Product Change Notification

June, 2007

Bourns® CD0603 & CD1005 Chip Diodes Substrate Material Change

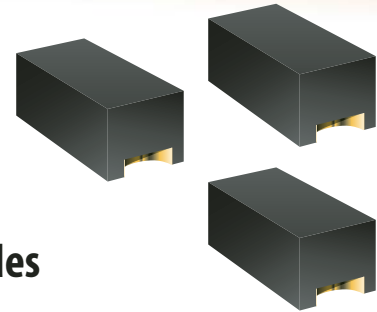
Over the past 12 months, Bourns has incurred large material cost increases for the packaging of chip diode products, especially with regard to the substrate, copper and gold materials, while lead times for raw material have also increased. To ensure continued product delivery and support to our customers, while remaining competitive on price for the Chip Diode devices, Bourns has initiated a product change from a BT substrate material to an FR5 substrate material for package assembly on the CD0603 and CD1005 chip diode part numbers. The change does not affect the electrical specifications of products, only the physical appearance.
